**Levy Nuclear Plant Units 1 and 2**  
**Response to NRC Request for Additional Information Letter No. 101 Related to**  
**SRP Section 2.4.6 for the Combined License Application, dated February 28, 2011**

**NRC Letter No.:** LNP-RAI-LTR-101

**NRC RAI NUMBER:** 02.04.06-17

**PGN RAI ID #: L-0902**

FIGURE 2.4.6-228

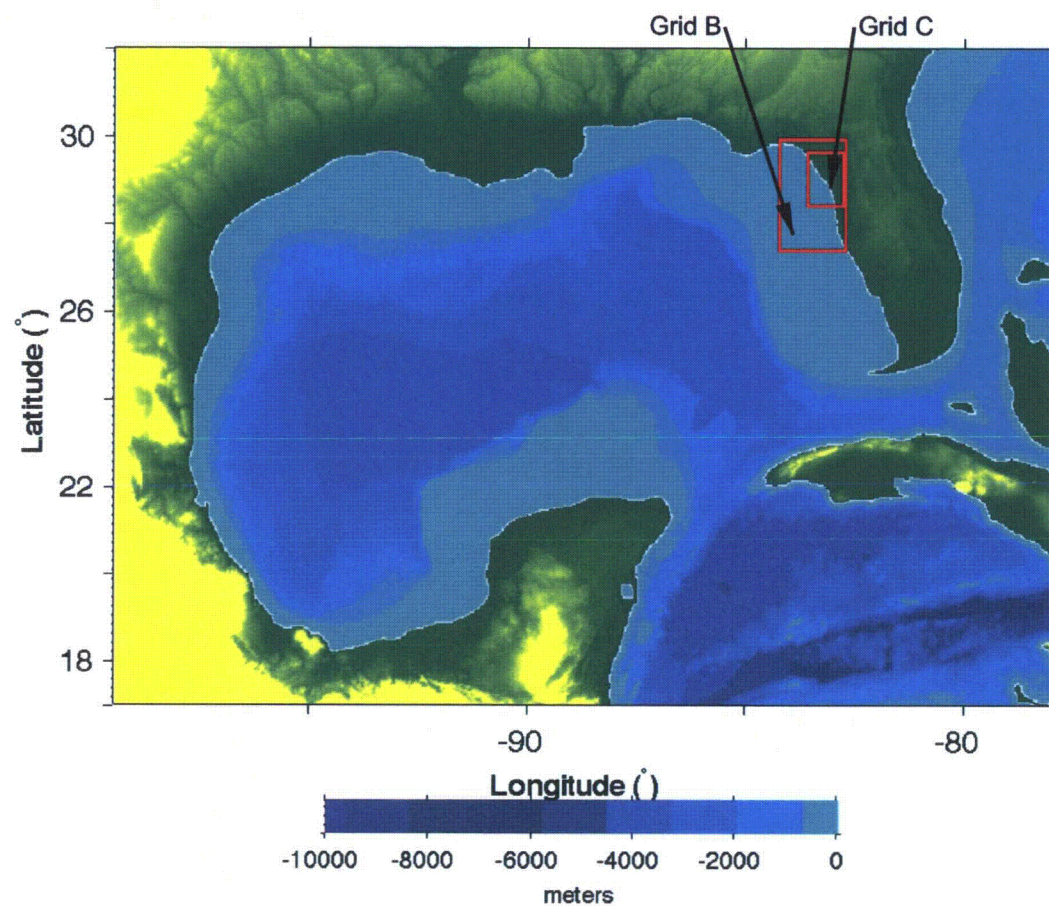
8. FSAR Table 2.4.6-209 through Table 2.4.6-211 (updated in response to NRC Letter 094, RAI 02.04.06-16 (NPD-NRC-2010-083, L-0867)) will be deleted.
9. FSAR Figure 2.4.6-228 will be replaced with new Figure 2.4.6-228 as presented in Attachment RAI 02.04.06-17-C.

FIGURE 2.4.6-229

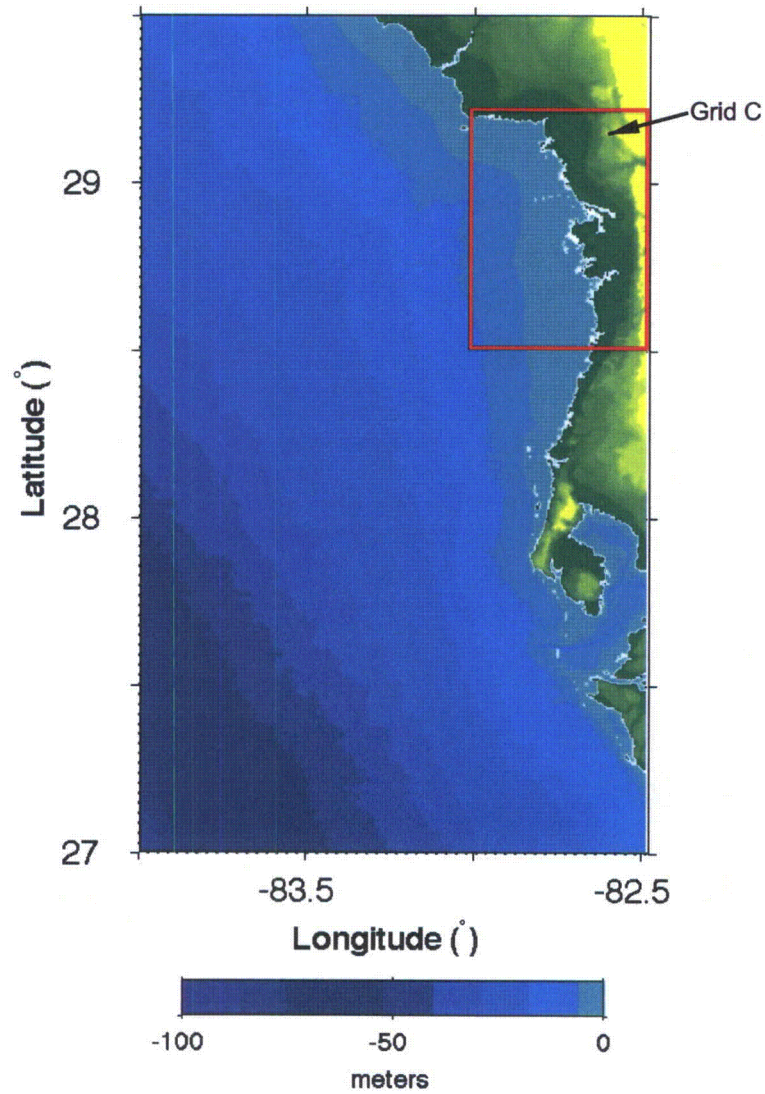
10. FSAR Figure 2.4.6-229 will be replaced with new Figure 2.4.6-229 as presented in Attachment RAI 02.04.06-17-C.
11. FSAR Figure 2.4.6-230 presented in response to NRC Letter 094, RAI 02.04.06-16 (NPD-NRC-2010-083, L-0867) will be replaced with new Figure 2.4.6-230 as presented in Attachment RAI 02.04.06-17-C.

FIGURE 2.4.6-230

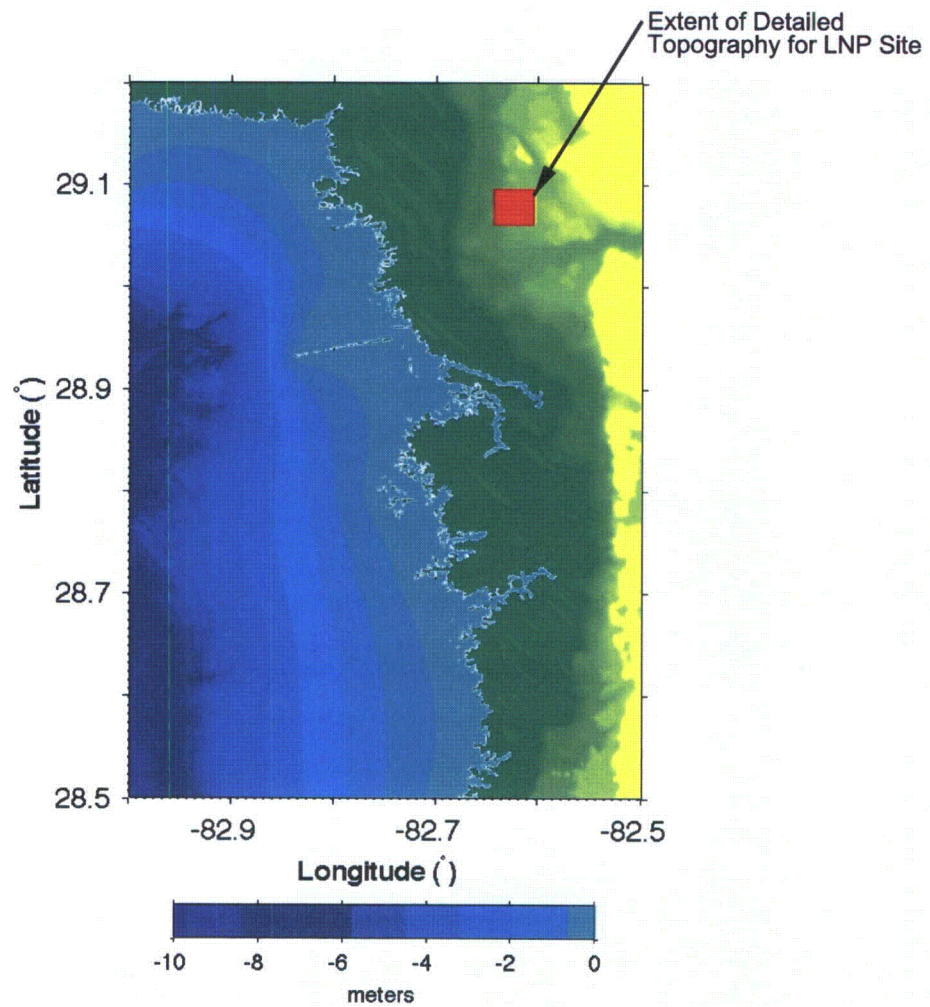
- (4) Provide the geographic location (lat, long) and water depth where the shoaled amplitude A(R) in Table 2.4.6-207 is calculated.
- (5) Provide location information for revised figure 2.4.6-230 "Landward Topographic Profile," for example, in a map figure.
